RESPONSE TO SUBMISSIONS: WENTWORTHVILLE NORTHSIDE WEST CLINIC EXTENSION

23-27 LYTTON STREET, WENTWORTHVILLE
LOT 1 DP787784

—
Prepared by Willowtree Planning Pty Ltd
on behalf of Ramsay Health Care

16 August 2022

Figure 2 East Elevation - Lytton Street View (Team 2 Architects 2022)

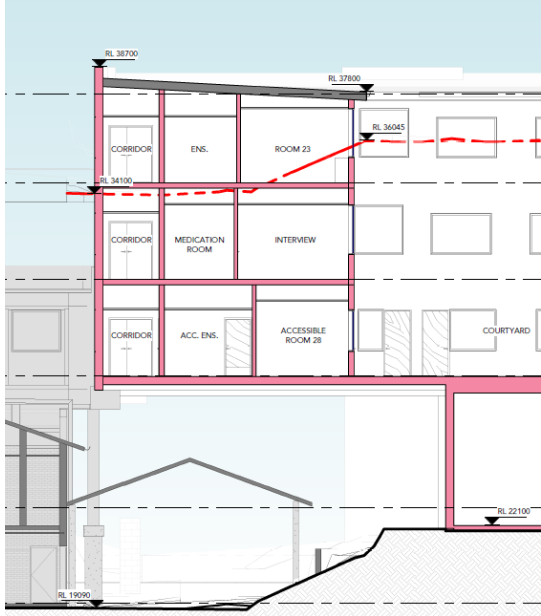
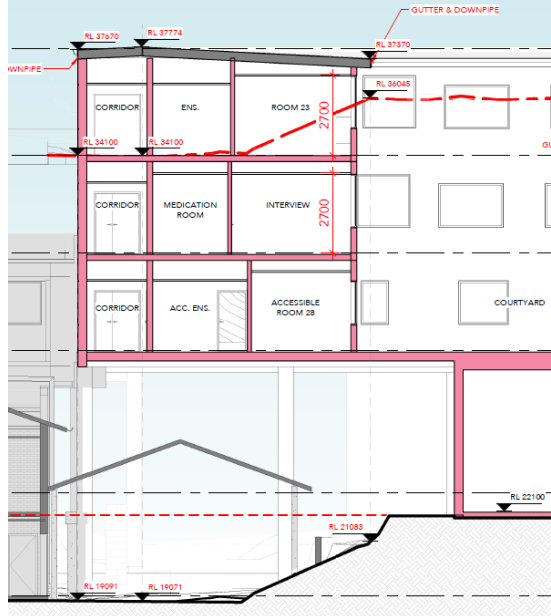
In response to submissions from DPE and Cumberland City Council, the building height of the proposed development has been reduced to 15.31m to 18.67m, representing a variation of 2% to 24.5% across the Site. As illustrated in **Figure 2**, the building height has been reduced on the eastern elevation and that the revised building height will be close to the 15m height limit measured at the site boundary. The building will appear to be approximately 15m in height when viewed from the streetscape of Lytton Street.

Figure 3 Shadow Diagrams on Winter Solstice (Team 2 Architects 2022)

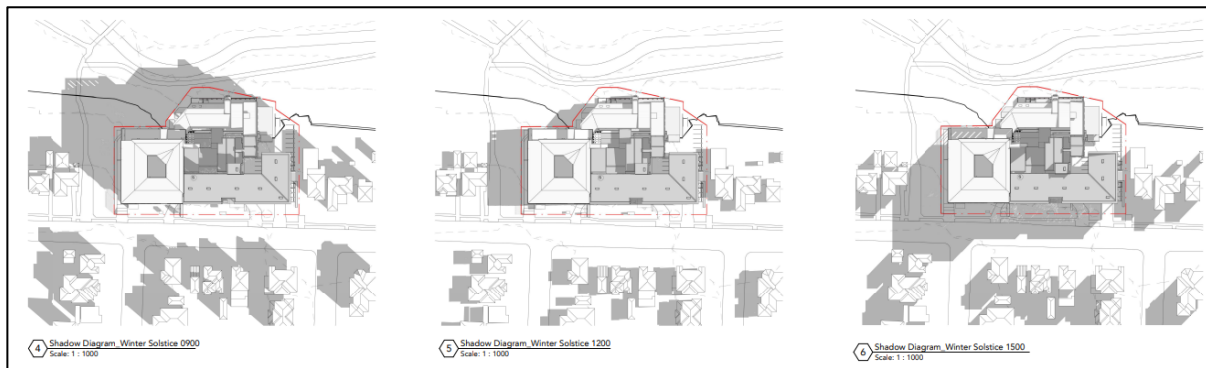
<ul style="list-style-type: none"> ○ demonstrate the overshadowing which would be created by the hanging planters, ensuring adequate solar access is experienced within this space and to internal rooms. 	<p>As illustrated in the Shadow Diagrams within the Architectural Plans, the courtyard and patient rooms will receive adequate solar access during summer solstice. It is noted that the patient rooms on Level 1 and 2 will continue to receive acceptable level of sunlight access on winter solstice. While the courtyard will be</p>

The proposed development as amended is considered to present a well-resolved built form that is sympathetic to the residential character of the area. As illustrated in the Shadow Diagrams in **Figure 3**, Lytton Street Park will continue to receive a minimum of three hours of natural sunlight between 12pm and 3pm on winter solstice. The residential property to the south of the Site will also continue to receive adequate sunlight access.

Figure 4 Location of three pylon signs along the Lytton Street frontage (Team 2 Architects 2022)

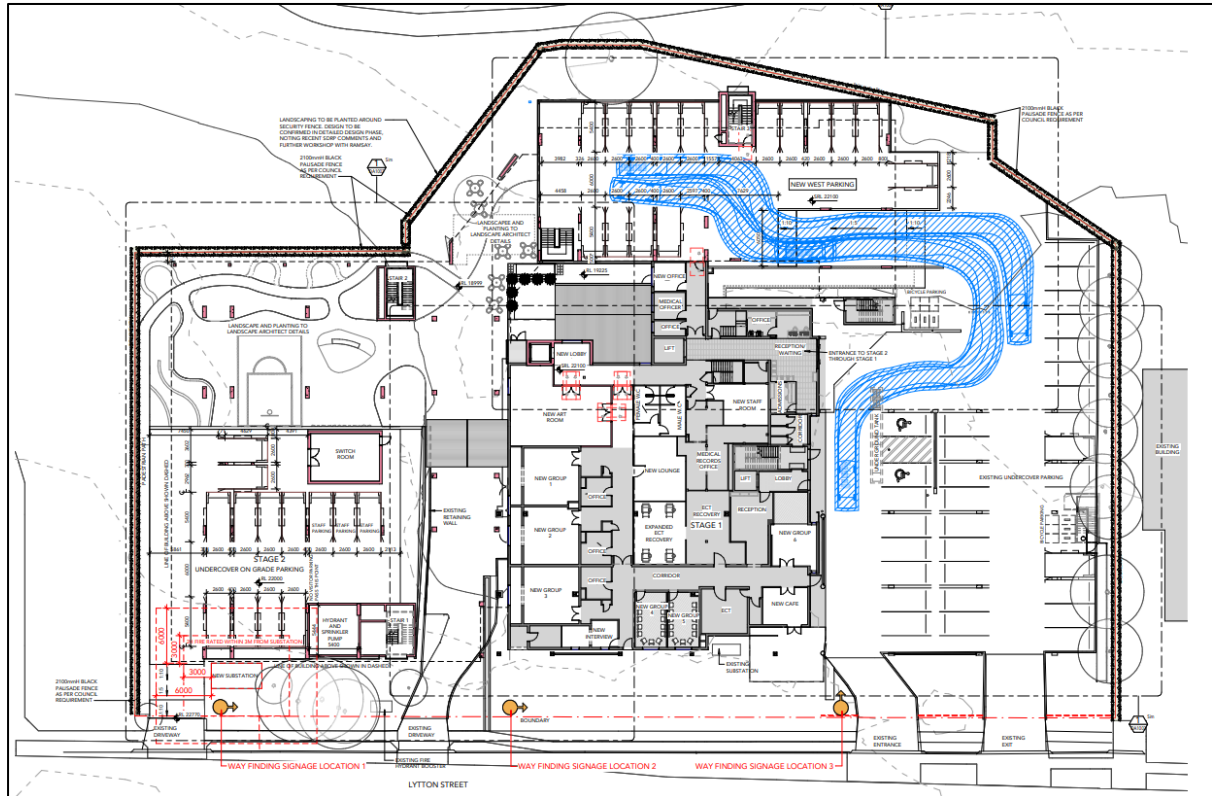
The proposed development as amended includes the installation of three pylon signs. The proposed pylon signs will 2.1m high and will be used for building identification and wayfinding purposes in response to DPE's comments. The proposed signs will be located at the front of the building along Lytton Street and will provide directions to the pedestrian entry of the building. The proposed development seeks approval for the location and indicative design of the signage. The design of the proposed signage will be further developed at detailed design stage. The location of the proposed pylon signs is illustrated in **Figure 4**.

Figure 11 Level 1 Inner Courtyard Landscape Design (Arcadia 2022)

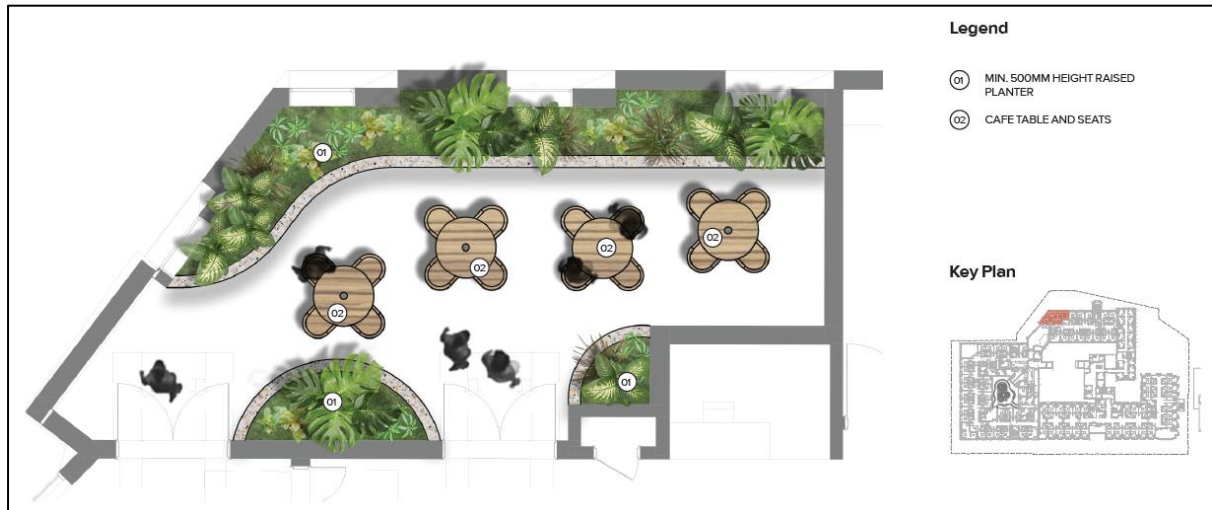
<ul style="list-style-type: none"> redesign courtyard 1 to ensure a more permanent and integrated landscaped space. 	The Level 1 courtyard design has been revised to provide planter wall integrated with timber seating, as well as additional planting bed provision. In addition, the planting species for the courtyard and hanging garden have been selected to suit the shaded environment within the building. The exposure information of the proposed planting species has been provided within the

Details of the landscape design on Lytton Street, in the Level 1 inner courtyard and Level 2 and Level 3 courtyards have also been included in the Landscape Plans and Strategy. The proposed landscape design in these areas is illustrated in **Figures 11-14**.

Figure 12 Level 2 Courtyard Landscape Design (Arcadia 2022)

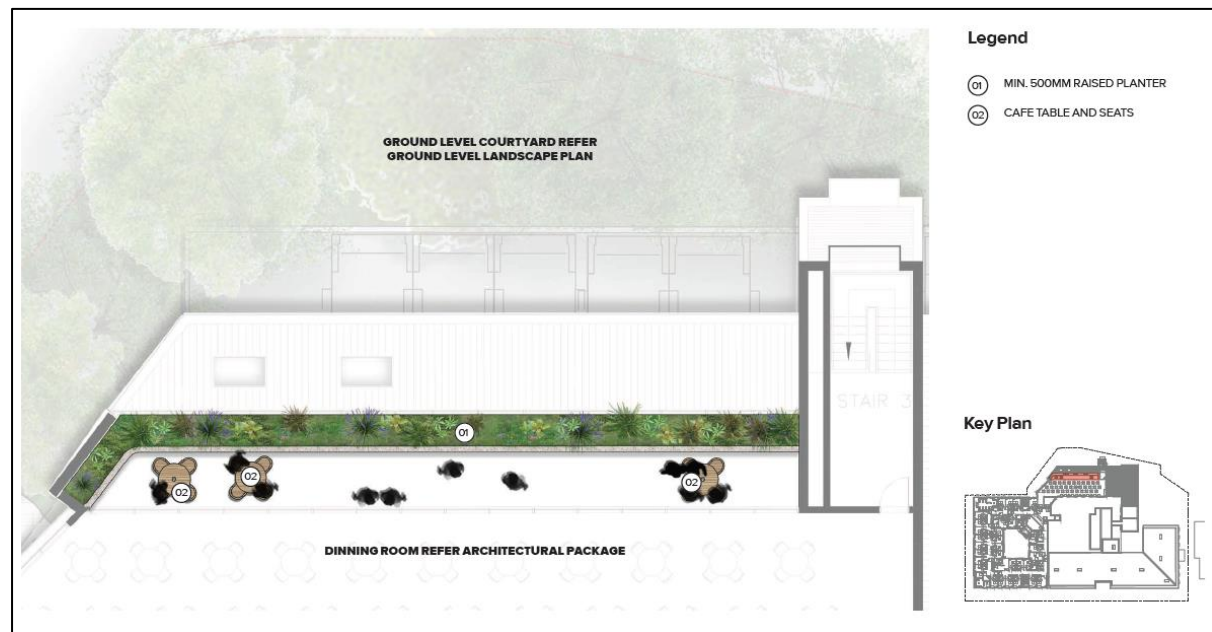
Include details of landscaping along Lytton Street providing improved amenity for the public ensuring visibility and appropriate sightlines are maintained as well as improved landscaping to soften the streetscape and utility rooms on ground floor. In addressing Council's detailed comments relating to fencing, confirm the fencing strategy and ensure consistency across all documents detailing the fencing design (i.e. detailed on all photomontages and architectural plans).	<p>Details of the Landscaping along Lytton Street are provided in the Landscape Plans and Strategy. Specifically, the landscaping along the Lytton Street streetscape includes proposed planting beds and trees which will soften the streetscape and built form on ground level whilst maintaining appropriate sightlines and visibility.</p> <p>As illustrated in the Architectural Plans, 2.1m black palisade fencing will be provided around the site boundaries in accordance with Council's comment. Landscaping will be planted around the security fence. Fencing design will be confirmed in detailed design phase, noting comments from the SDRP and further workshop with Ramsay Health Care.</p>
